Proposed Corriegarth 2 Wind Farm: Response to SEPA Consultation Request

Appendix A – Amended Figures

Corriegarth 2 Wind Farm

Reproduced from Ordnance Survey digital map data © Crown copyright 2021. All rights reserved. License number 100048606

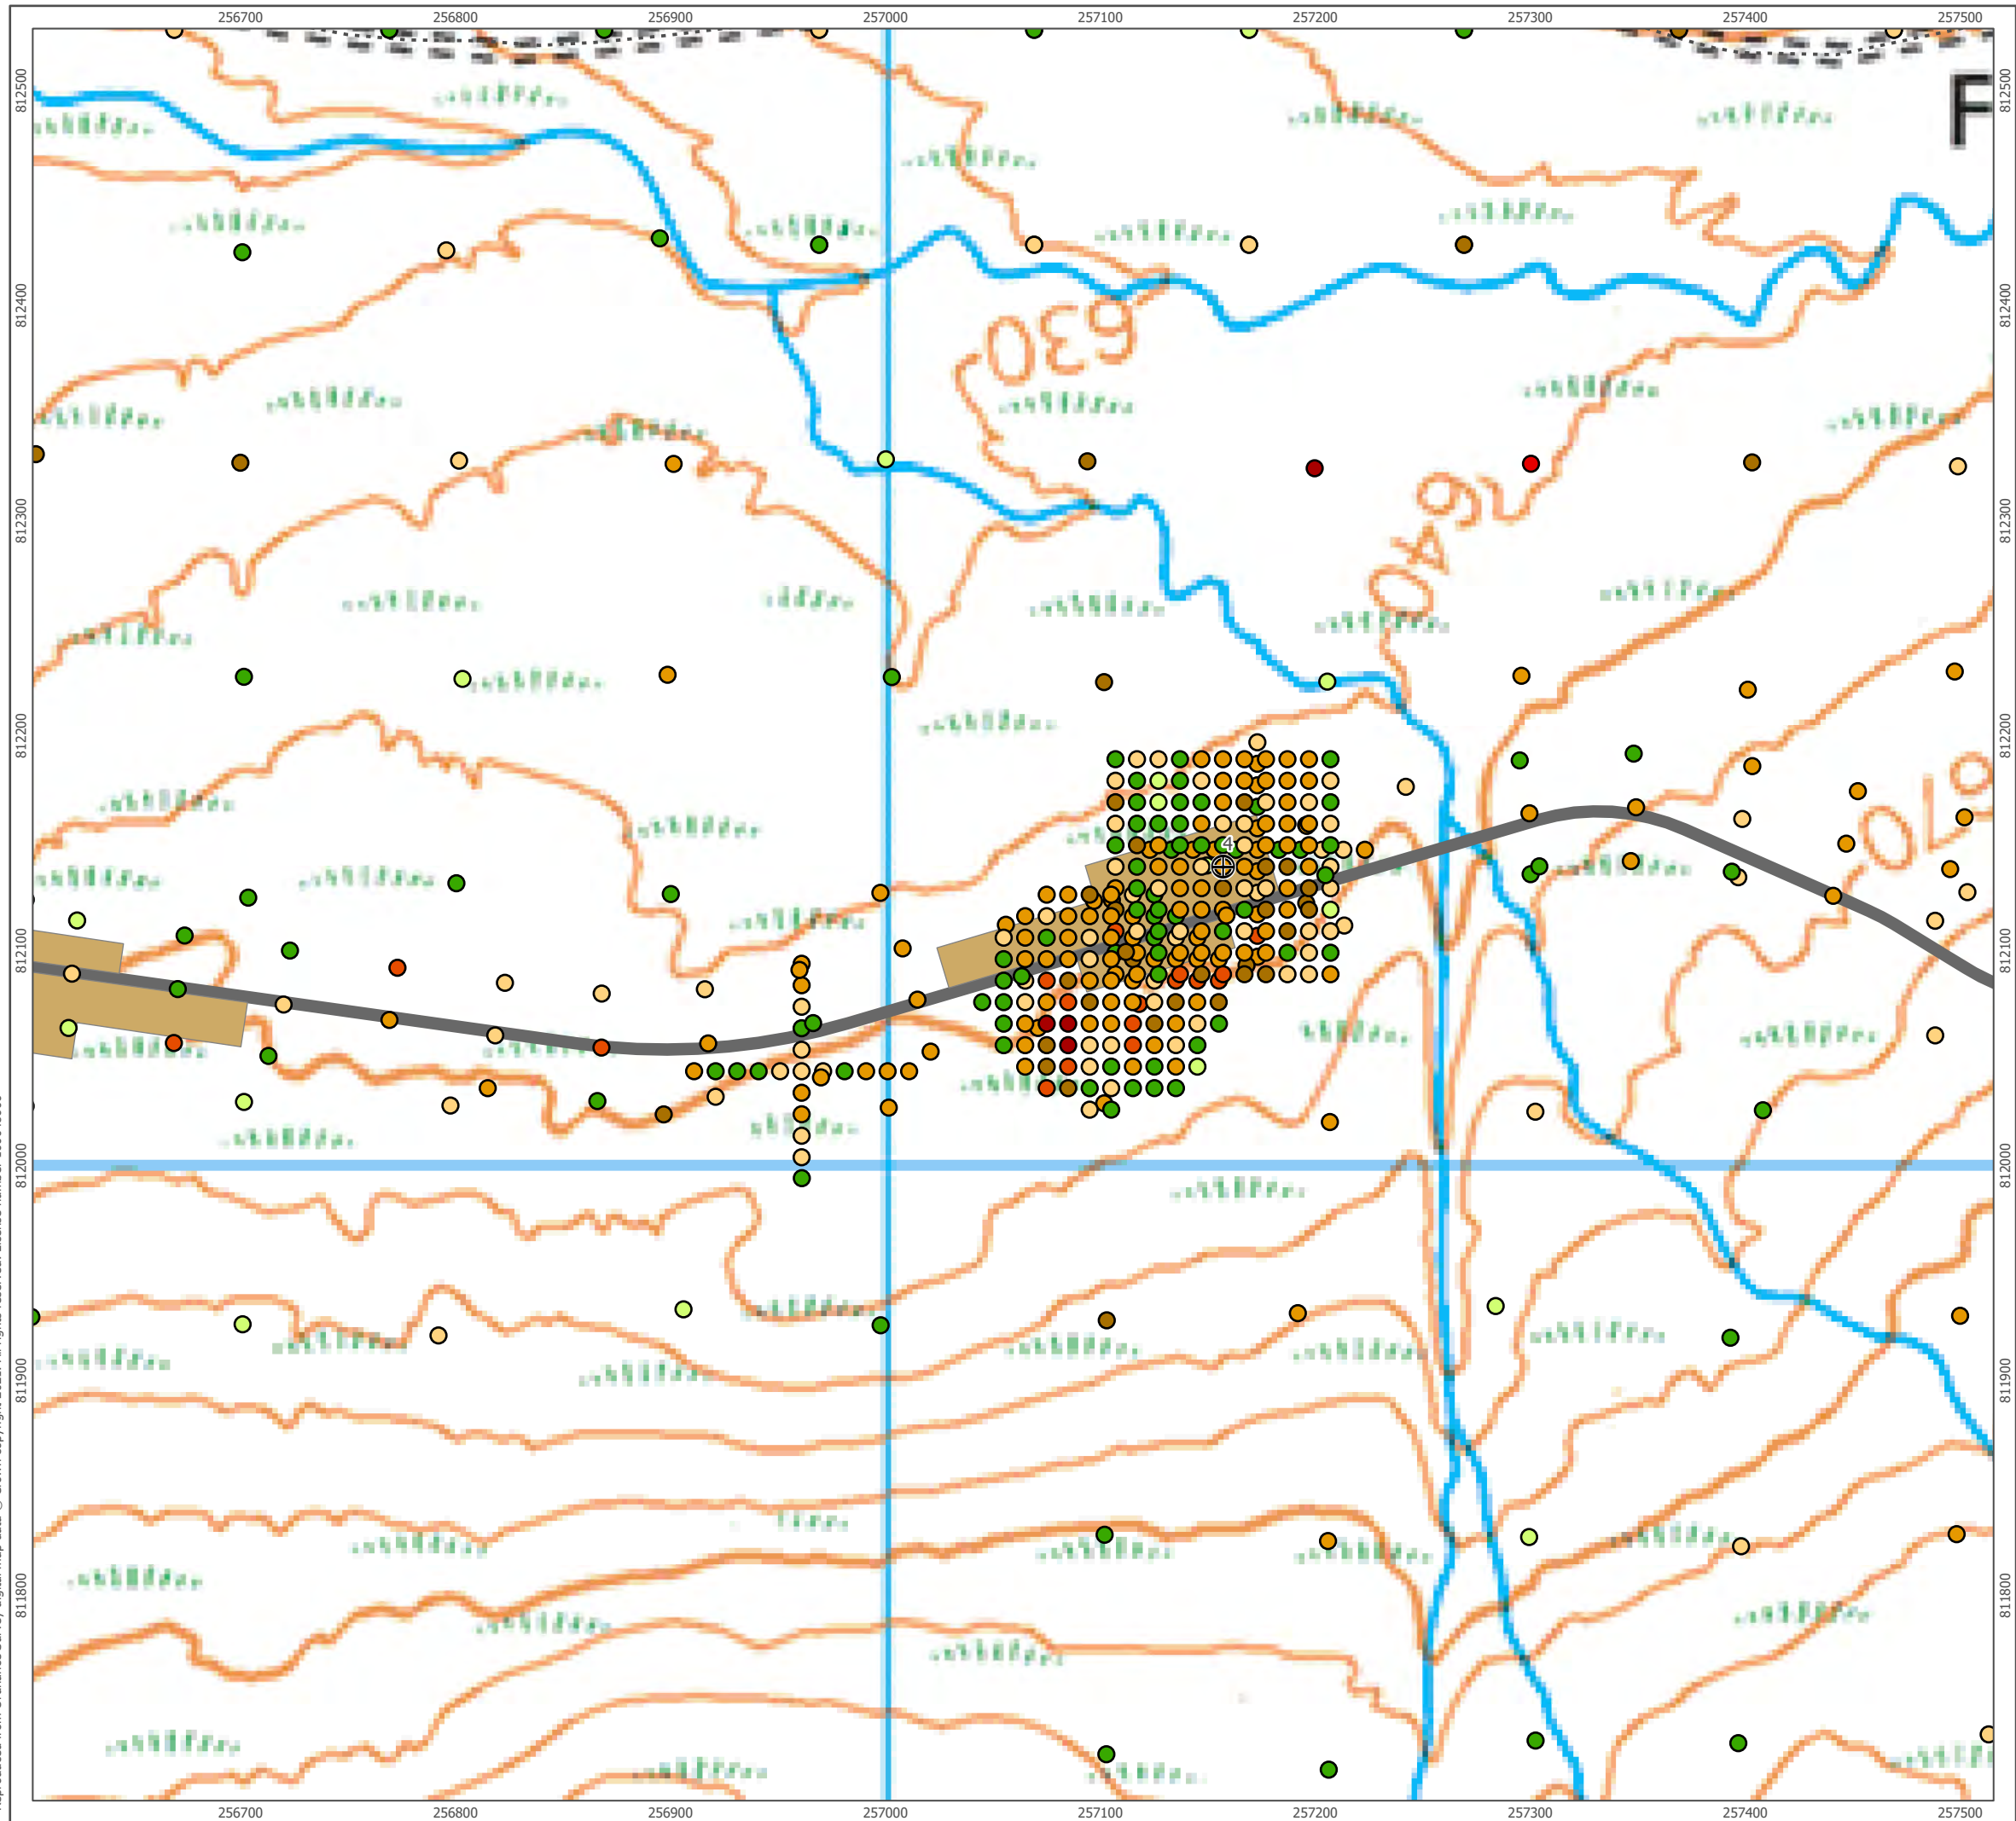
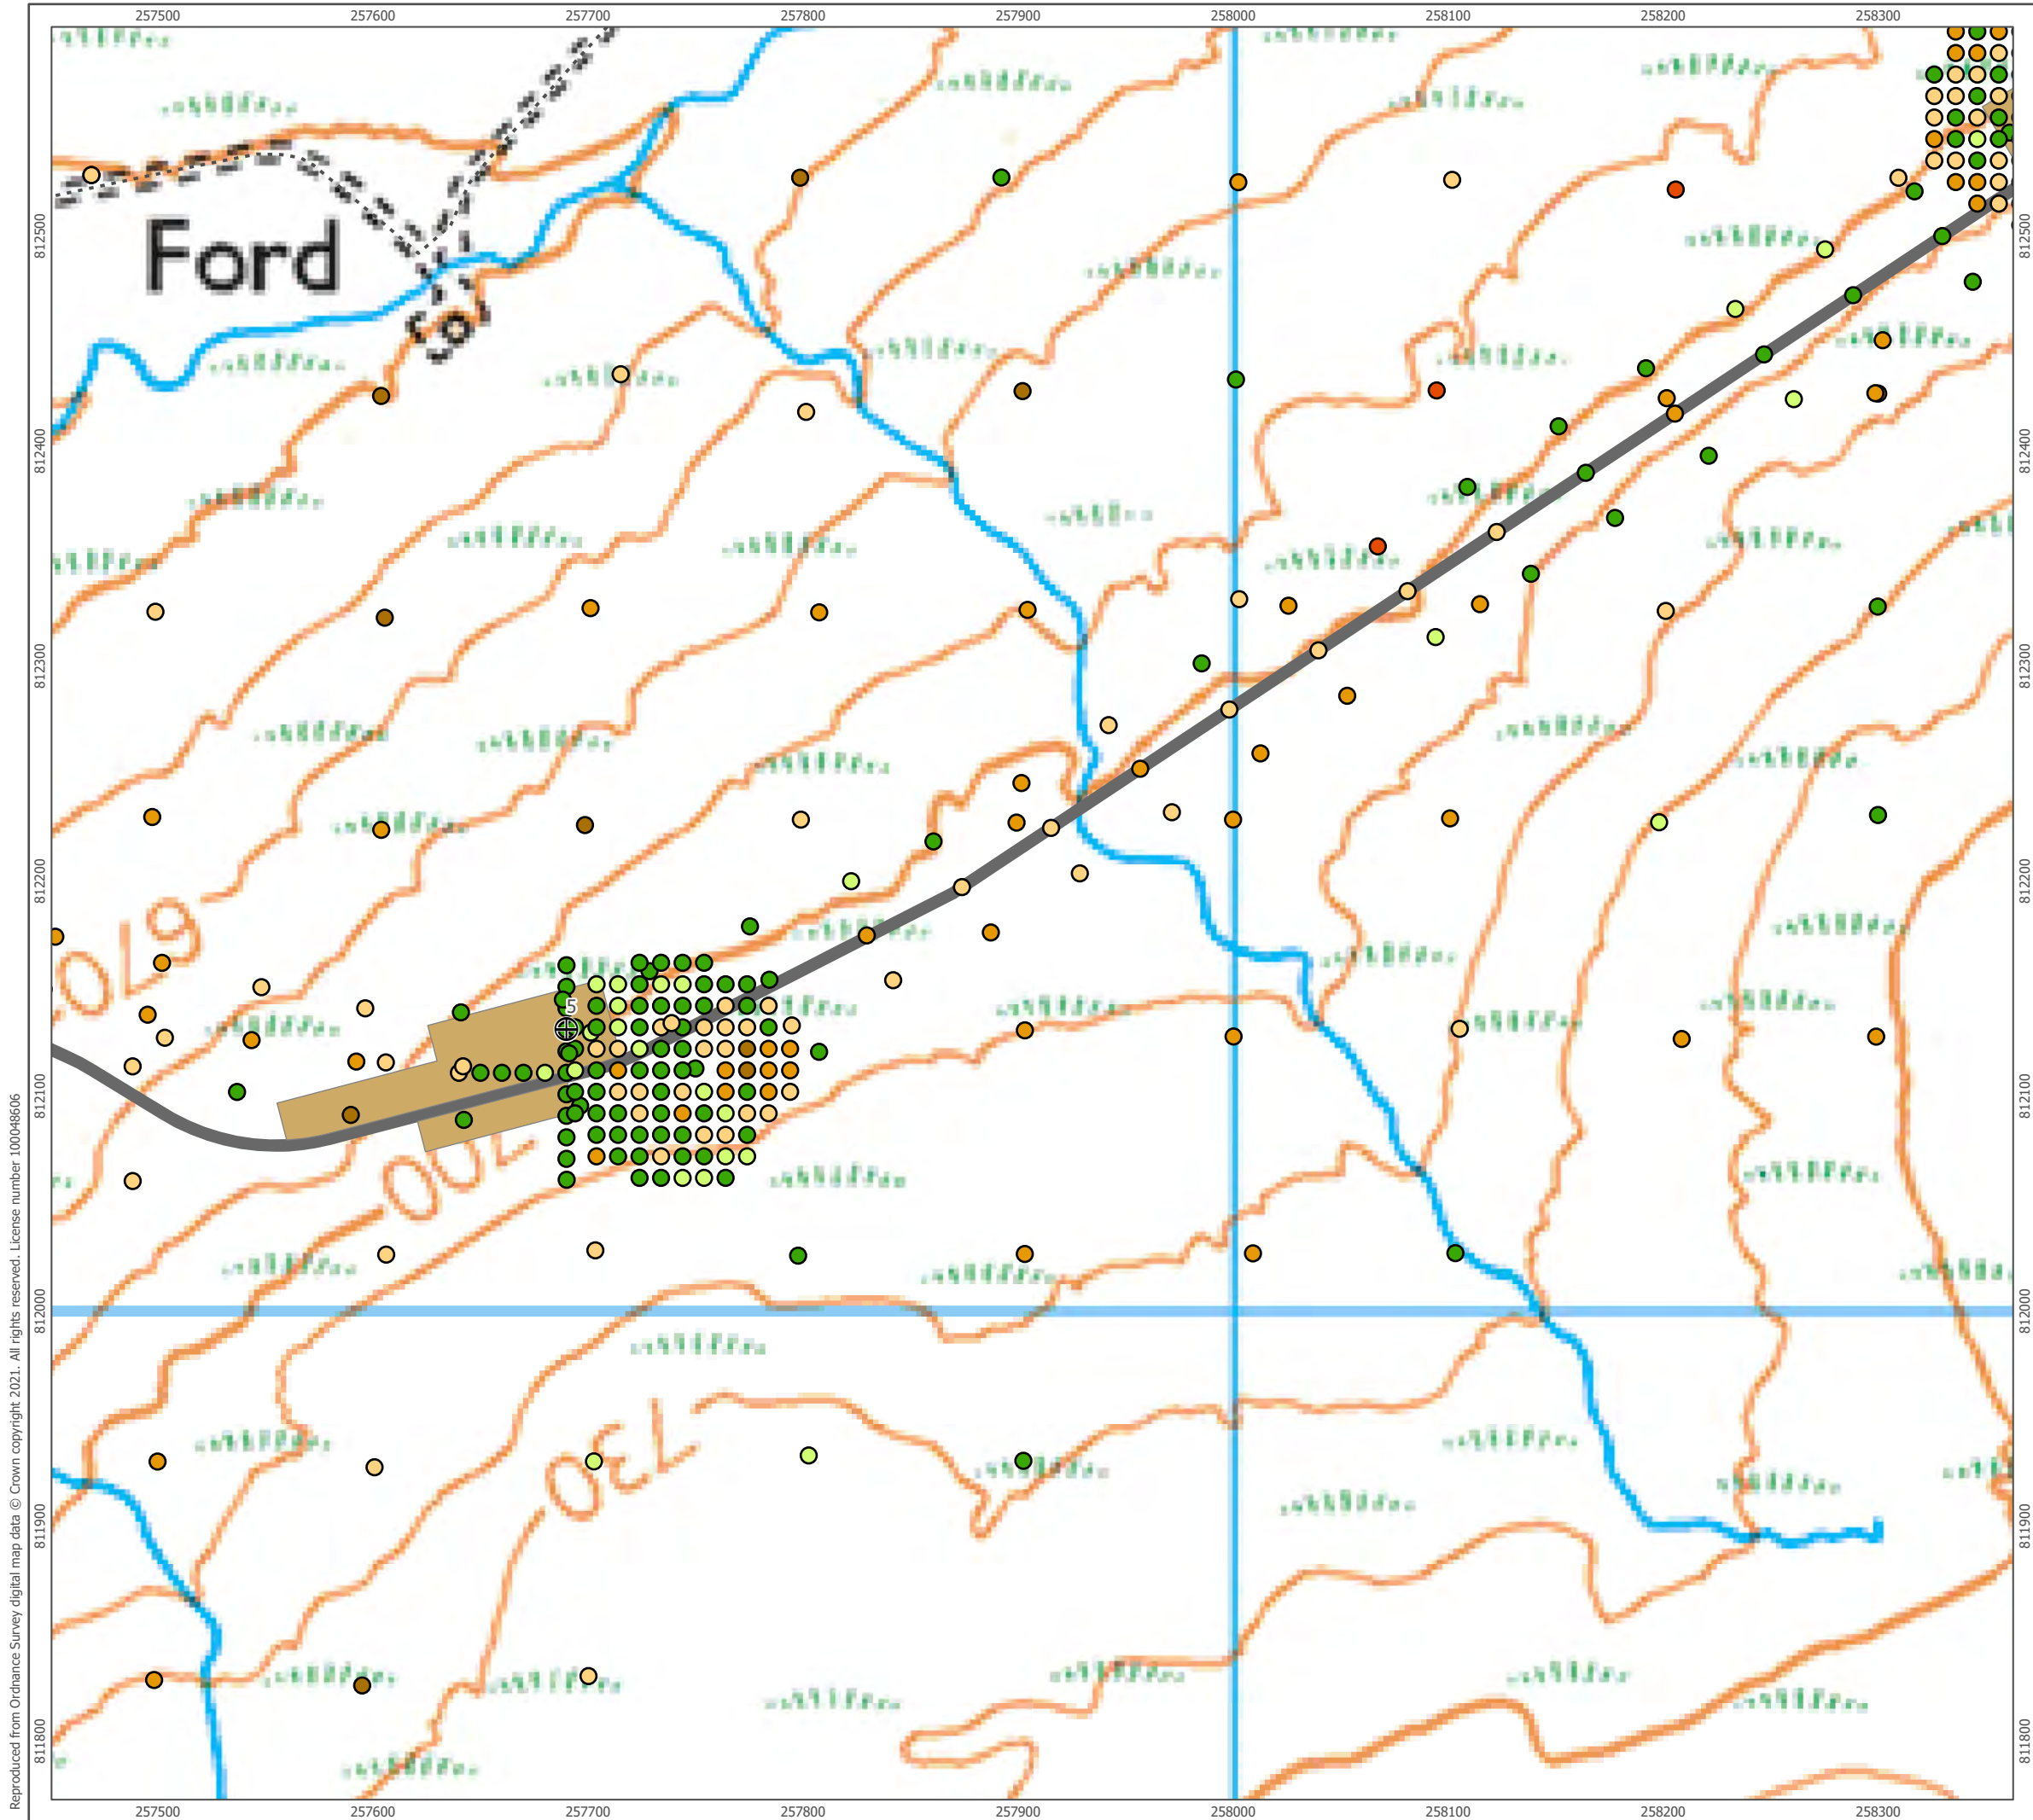
1. Figure 7.2 of Chapter 7: Ecology of the EIA Report is amended to include all proposed infrastructure associated with the Development (clearly marked);
2. All of the figures contained within Technical Appendix A7.1: Habitats and Botany Surveys to include all proposed infrastructure associated with the Development (clearly marked); and
3. Figure 13.2.2 of Technical Appendix A13.2: Outline Peat Management Plan to be provided on OS Basemapping; to be provided in a map series format; and with a revised symbology colour ramp.

3.	Figure 13.2.2 has been amended to include 25k OS Basemapping, as requested. Additionally, the figure is now spread over several maps providing a more appropriate scale for the reader to understand the peat probe depths more accurately in relation to infrastructure. A revised colour ramp has also been provided.
